Virginia Board of Housing and Community Development
CODES AND STANDARDS COMMITTEE
2018 CODE CHANGE CYCLE – BOOK 6
October 19, 2020

TAB 1 – USBC Proposals Recommended by Workgroups as Consensus for Approval (approve individually or as a block)

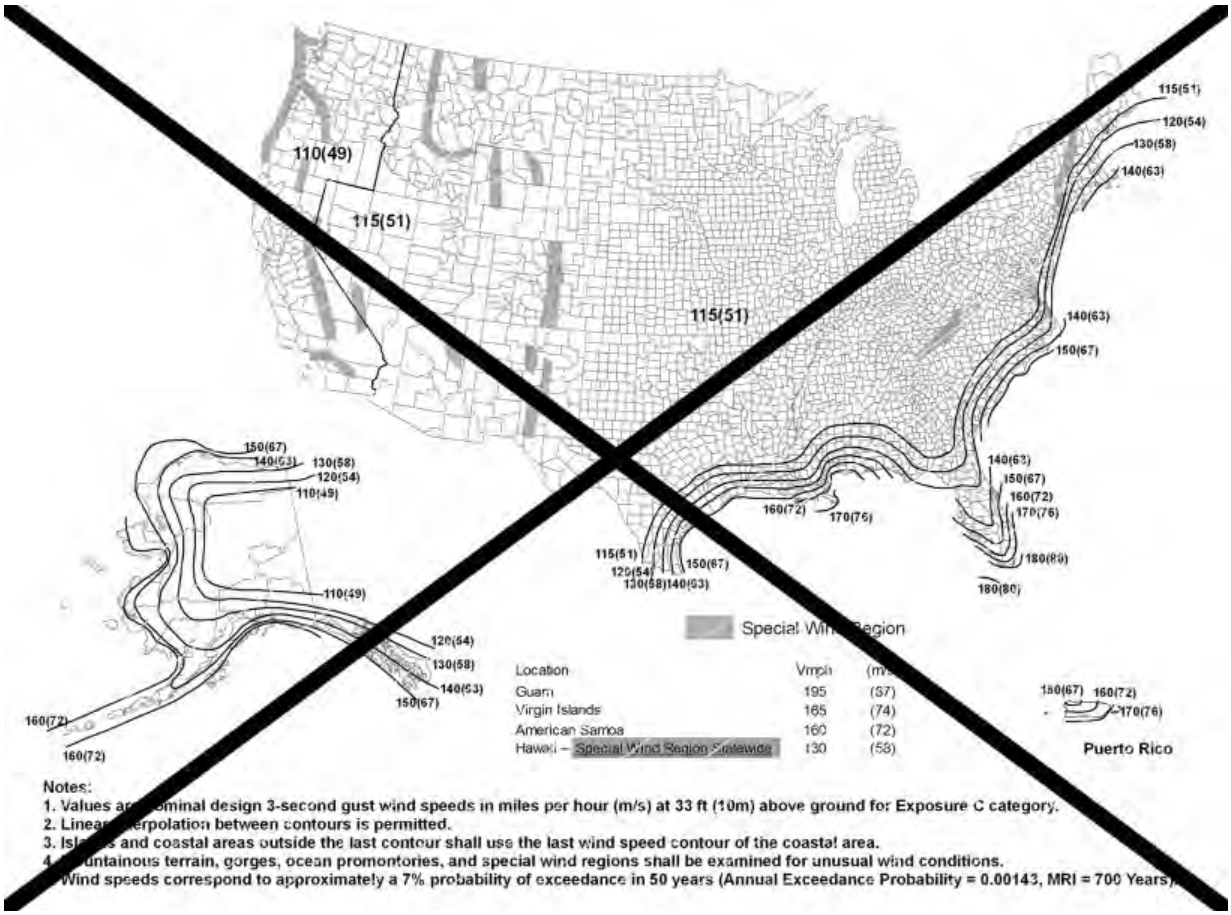
The simplified component and cladding loads in Table R301.2(2) are proposed to be revised for correlation with the new roof component and cladding loads for buildings with mean roof heights less than or equal to 60 feet. The roof zones and pressure coefficients in ASCE 7-16 Figure 30.4-2 (which includes Figures 30.4-2A through 30.4-2I) have been revised based on an analysis of an extensive wind tunnel database. All source data used in the study are publicly accessible through the National Institute of Standards and Technology (NIST) website.
Compared to previous versions of ASCE 7, the pressure coefficients have been increased, and are now more consistent with coefficients for buildings higher than 60 feet. Roof zones sizes are also modified from those of earlier versions in order to minimize the increase of pressure coefficients in Zones 1 and 2. The data indicate that for these low-rise buildings, the size of the roof zones depend primarily on the building height, h. The GCp values given in ASCE 7-16 Figures 30.4-2A through 30.4-2I are associated with wind tunnel tests performed in both Exposure B and C. For ASCE 7-16 Figure 30.4-2A, the coefficients applly equally to Exposure B and C, based on wind tunnel data that show insignificant difference in (GCp) for Exposure B and C. Consequently, the truncation for Kz in Table 30.3-1 of ASCE 7-10 is not required for building below 30 feet, and the lower Kz values may be used as shown revised in Figure R301.2(3) of the IRC.

NOTE: Due to cdpVA functionality, the revised Table R301.2(2) was added as a NEW table, however, it is intended to replace the existing R301.2(2) (i.e., delete existing Table R301.2(2). Also, in the NEW table, only footnotes f and g are NEW. The footnotes a to e remain unchanged from previous IRC, but only look new due to cdpVA legislative format editor. Lastly, Table 301.2(3) includes only three revised values but they do not seem to appear in legislative format. The revisions are limited to the first three entries for Exposure Category B where 1.00 for each was replaced with 0.82, 0.89, and 0.94, respectively.

FIGURE R301.2(4)A
ULTIMATE DESIGN WIND SPEEDS

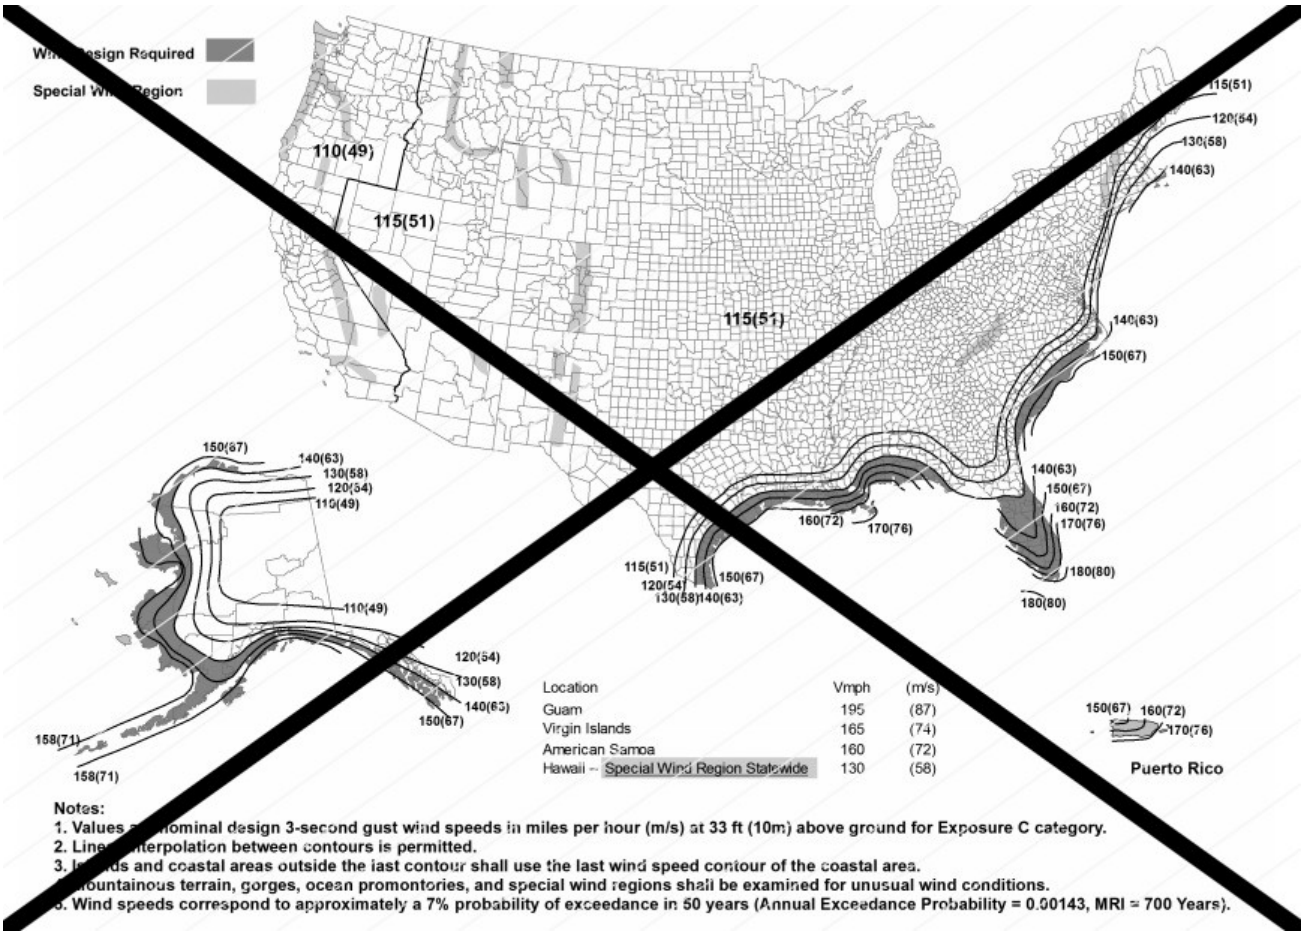
Reason Statement: This proposal is a coordination proposal to accompany the proposal to update the wind map in Figure R301.2(4)A to the currently referenced ASCE 7-16 standard. As has been stated, the ASCE 7-16 wind maps include many areas of the country where wind speeds decreased below the speeds of the previous maps. To coordinate the IRC with the areas of lower wind speeds, this proposal adds or modifies existing provisions to account for these lower speeds. This proposal includes several changes that are bundled together in one proposal because they all reflect the effort to accommodate for these lower speeds in the existing tables and figures. Each change within this proposal is explained below.

R301.2.1 Wind design criteria. Buildings and portions thereof shall be constructed in accordance with the wind provisions of this code using the ultimate design wind speed in Table R301.2(1) as determined from Figure R301.2(4)A. The structural provisions of this code for wind loads are not permitted where wind design is required as specified in Section R301.2.1.1. Where different construction methods and structural materials are used for various portions of a building, the applicable requirements of this section for each portion shall apply. Where not otherwise specified, the wind loads listed in Table R301.2(2) adjusted for height and exposure using Table R301.2(3) shall be used to determine design load performance requirements for wall coverings, curtain walls, roof coverings, exterior windows, skylights, garage doors, and exterior doors. Asphalt shingles shall be designed for wind speeds in accordance with Section R905.2.4. A continuous load path shall be provided to transmit the applicable uplift forces in Section R802.11.1 from the roof assembly to the ~~foundation.~~ foundation. Where ultimate design wind speeds in Figure R301.2(4)A are less than the lowest wind speed indicated in the prescriptive provisions of this code, the lowest wind speed indicated in the prescriptive provision of this code shall be used. Wind speeds for localities in special wind regions, near mountainous terrain, and near gorges shall be based on elevation. Areas at 4,000 feet (1219 m) in elevation or higher shall use the nominal design wind speed of ~~110 mph (48.4 m~~ 140 mph (62.6 m/s) and areas under 4,000 feet (1219 m) in elevation shall use nominal design wind speed of ~~90 mph (39.6 m~~ 110 mph (49.2 m/s). Gorge areas shall be based on the highest recorded speed per locality or in accordance with local jurisdiction requirements determined in accordance with Section ~~26.5.1 of~~ 26.5.2 of ASCE 7.

FIGURE R301.2(4)B
REGIONS WHERE WIND DESIGN IS REQUIRED

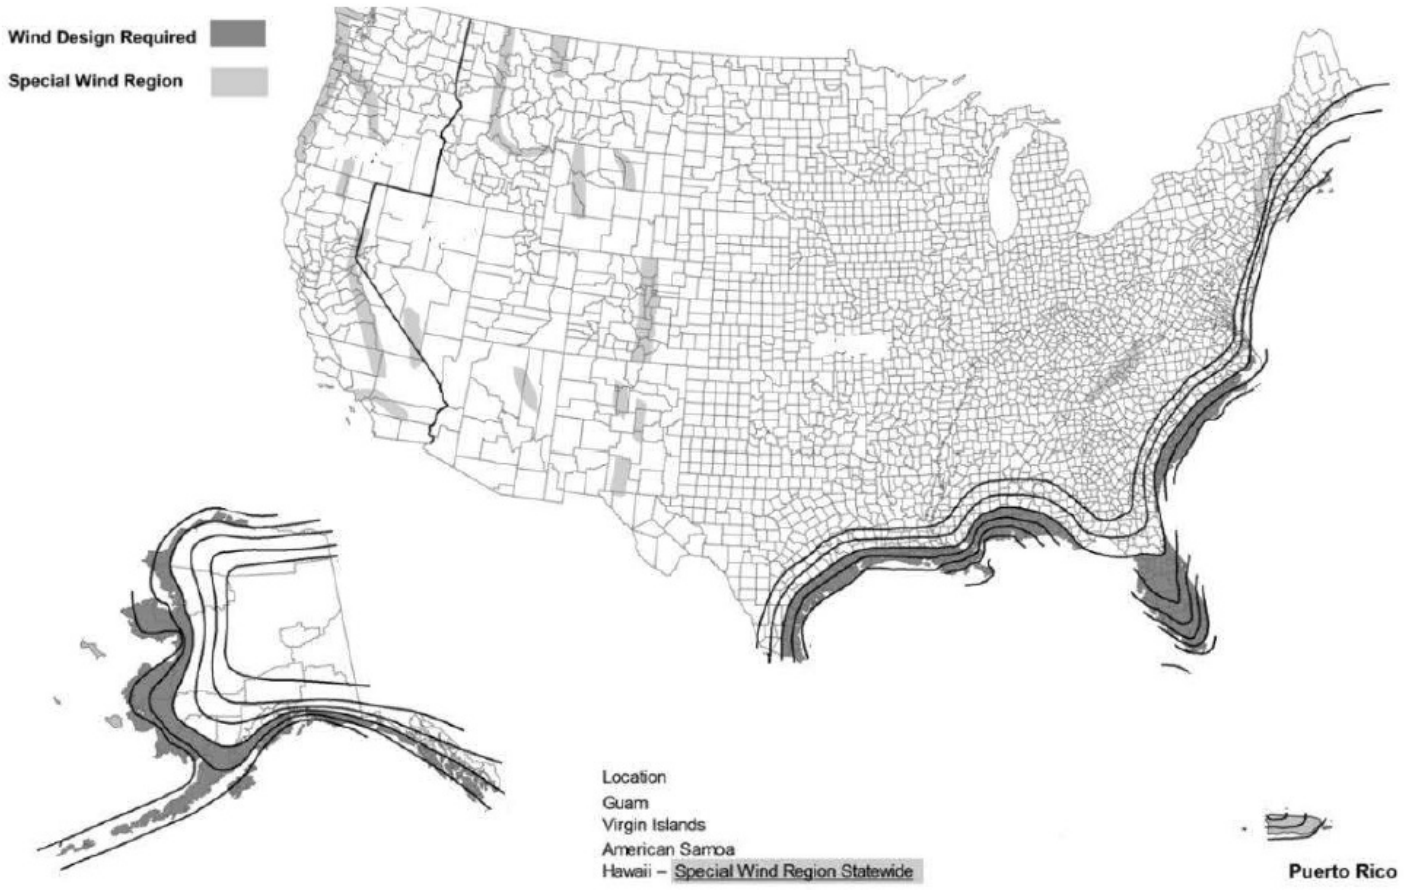
R301.2.1.1 Wind limitations and wind design required. The wind provisions of this code shall not apply to the design of buildings where wind design is required in accordance with Figure ~~R301.2(5)B.~~ R301.2(5)B or where the ultimate design wind speed, V_{alt} in Figure R301.2(5)A equals or exceeds 140 mph in a special wind region.

In regions where wind design is required in accordance with Figure R301.2(5)B or where the ultimate design wind speed V_{alt} in Figure R301.2(5)A equals or exceeds 140 mph in a special wind region, the design of buildings for wind loads shall be in accordance with one or more of the following methods:

FIGURE AH106.4.1
ULTIMATE DESIGN WIND SPEEDS FOR PATIO COVERS AND SCREEN ENCLOSURES

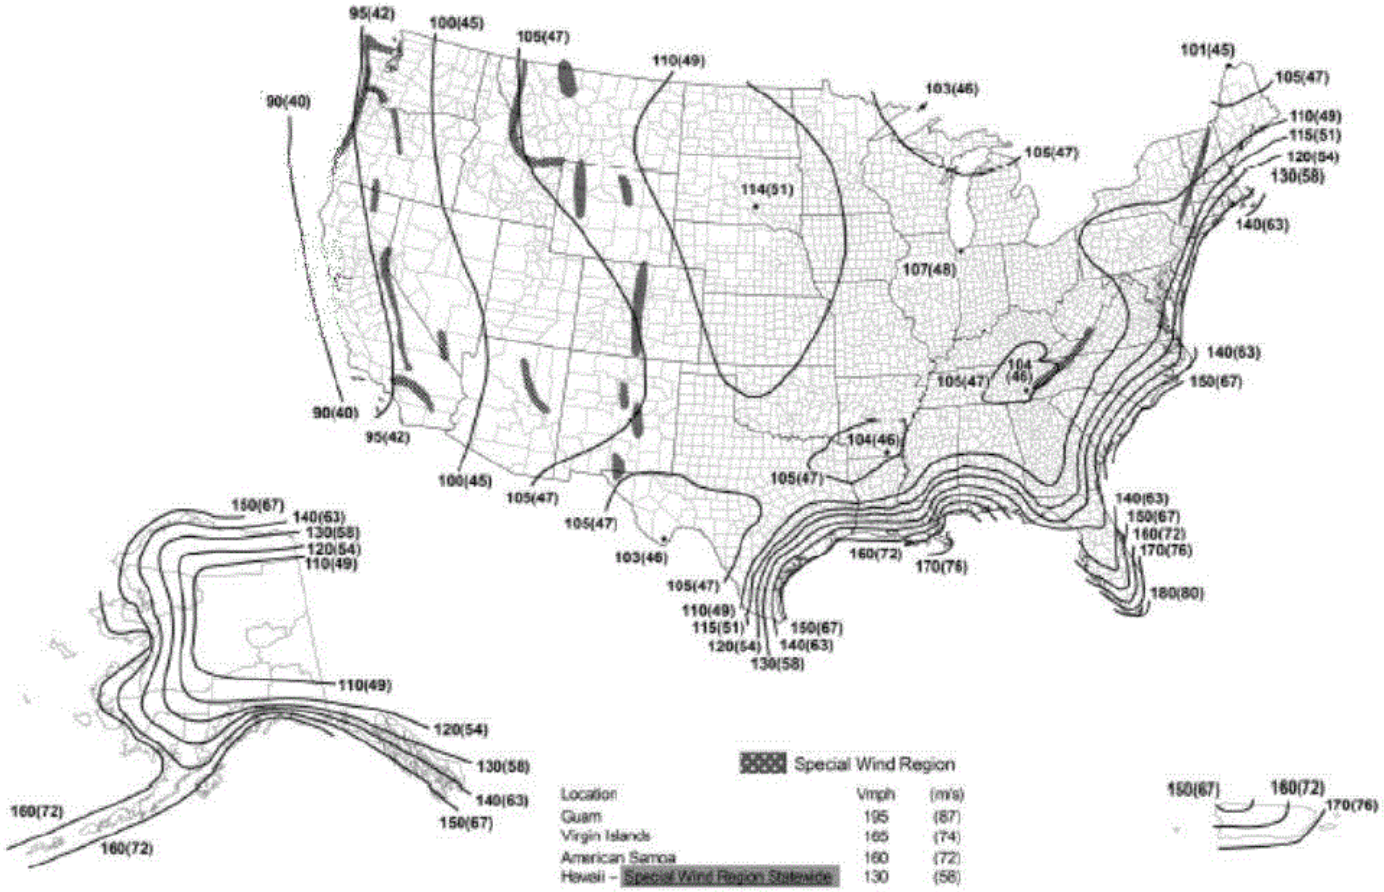
Figure AH106.4.1 Ultimate Design Wind Speeds for Patio Covers and Screen Enclosures
This updates the map to the ASCE 7-16 RC

FIGURE R301.2(5)A
ULTIMATE DESIGN WIND SPEEDS

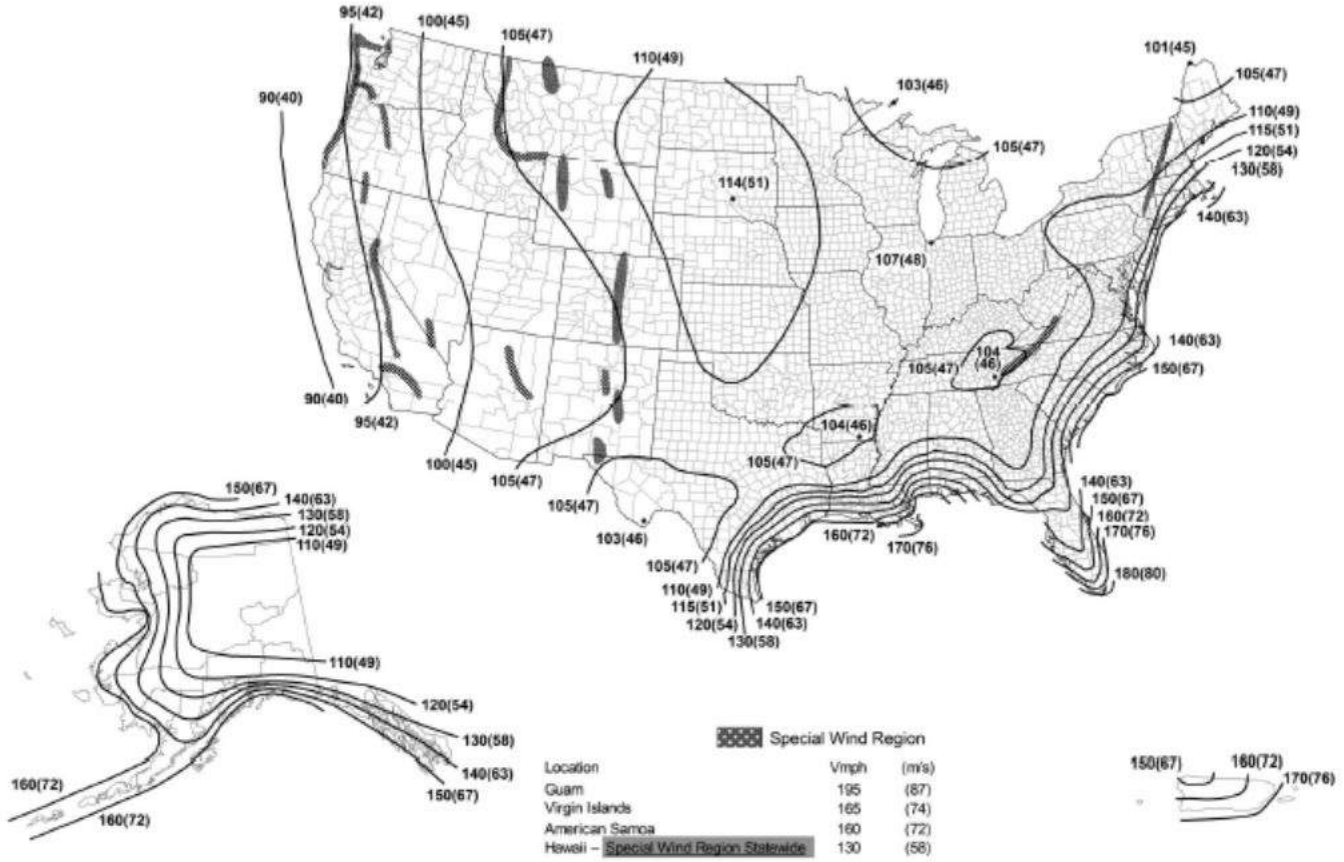
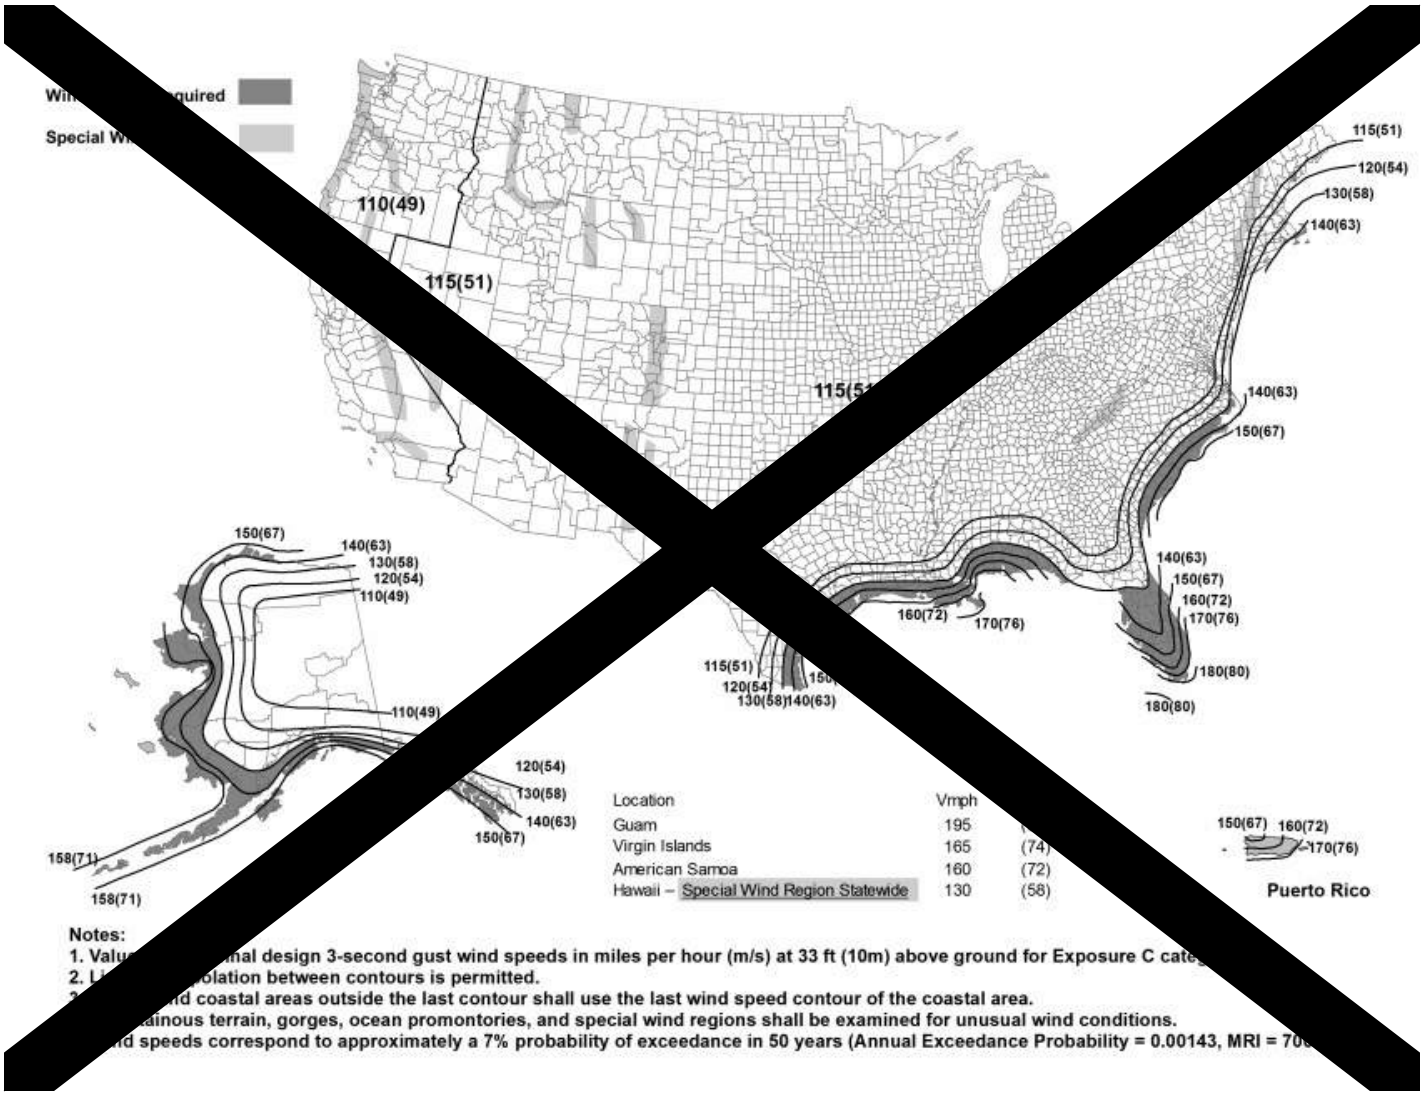
~~FIGURE R301.2(5)A~~
~~ULTIMATE DESIGN WIND SPEEDS~~

FIGURE R301.2(5)B
REGIONS WHERE WIND DESIGN IS REQUIRED

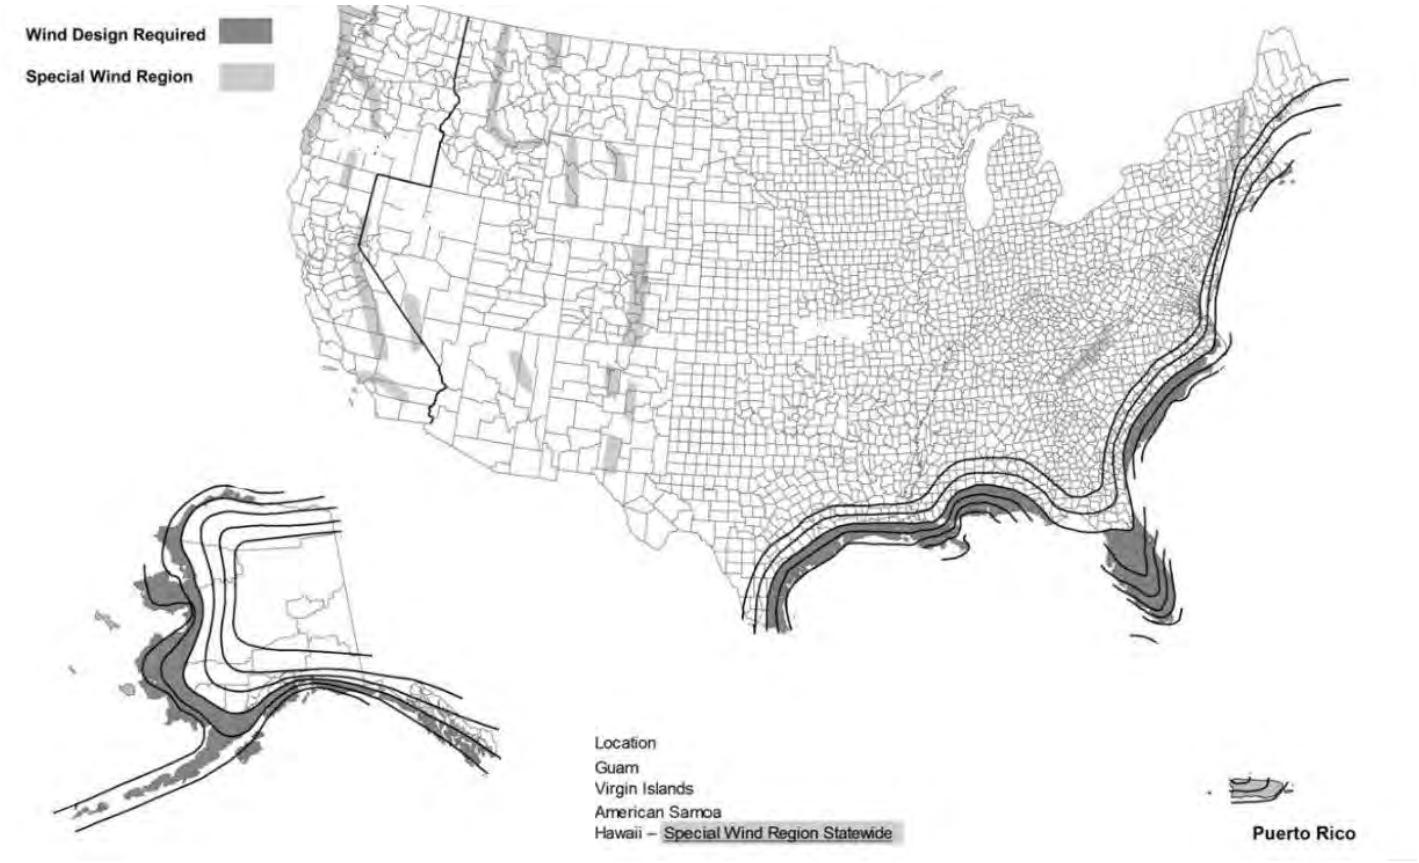
Revise as follows:
